# **JTC Engineering VPCR Response**

**Odin Breather Hose**

**Contacting Shutoff Valve  
on Intake Manifold**

**By:** Jessica Nicholson

# Failing Component and Potential Effects

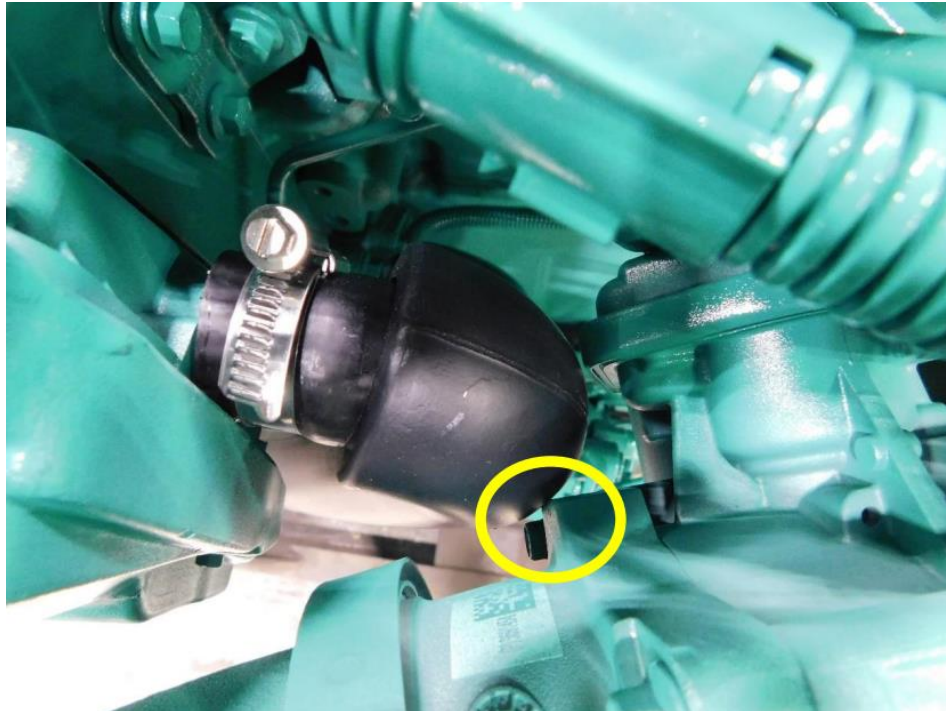
- Odin breather hose is difficult to install due to size and tight fit
- Insulation covering hose makes contact with the shutoff valve
- May create long-term wear on insulation and shutoff valve during operation

- Remove a section of insulation from top part of breather hose
  - Identify location where insulation makes contact with shutoff valve
  - Mark this location on hose
  - Mark how much insulation must be removed to prevent contact
- Engine heat is sufficient to prevent top section of breather hose from freezing without insulation
  - Insulation is unnecessary at the top of the breather hose, obsolete feature
  - Automotive hose demonstrates this
- Automotive breather hose (3688597) has no top insulation
  - Current insulated Odin hose (5348266) is longer than the automotive model
  - We cannot replace the Odin hose with the automotive model
- Must modify insulation for existing Odin breather hose

# Redesign Process – Identify Location of Contact

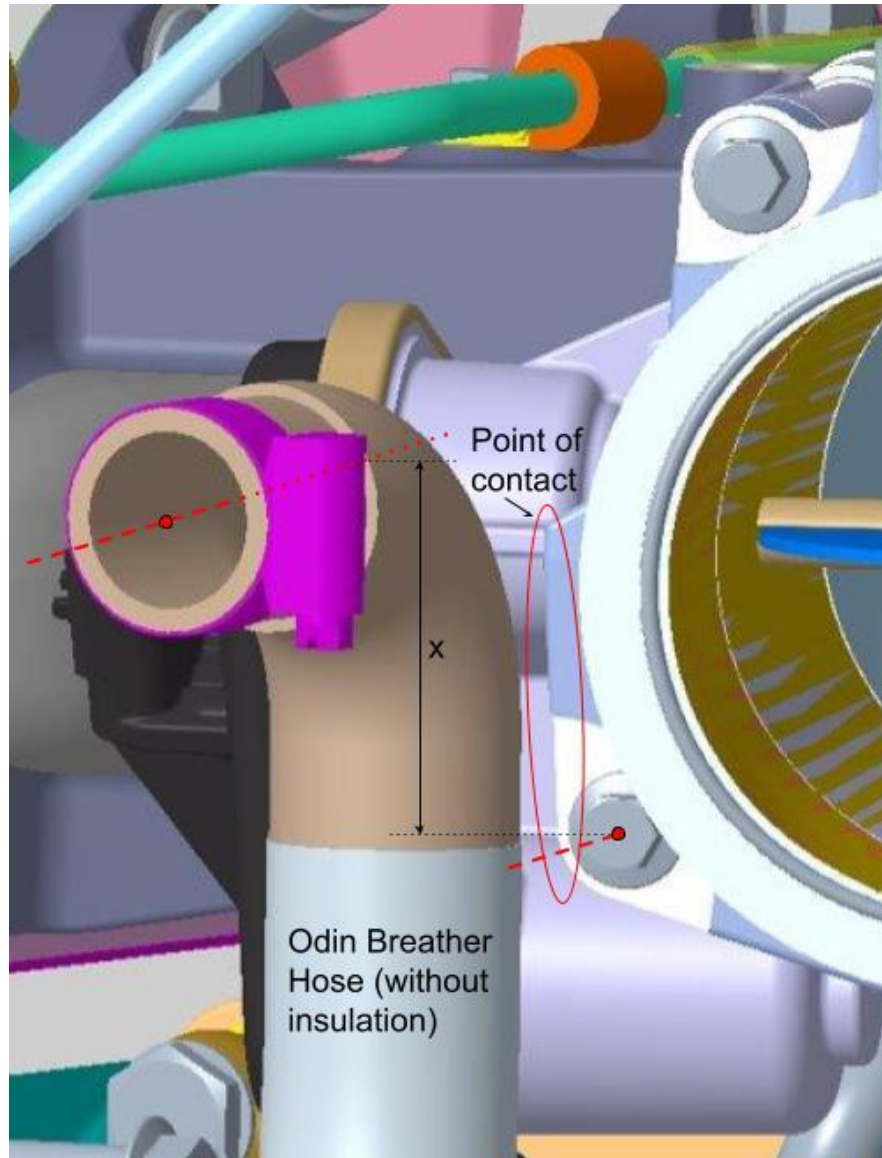
- Distance from top of hose centerline to lowest possible insulation contact point  $x = 47.7$  mm
- Insulating tube from the top of the hose must be removed so that there is no insulation above 47.7 mm from this centerline
- To allow for plenty of clearance, we should remove at least **75 mm** of insulation from the top hose centerline
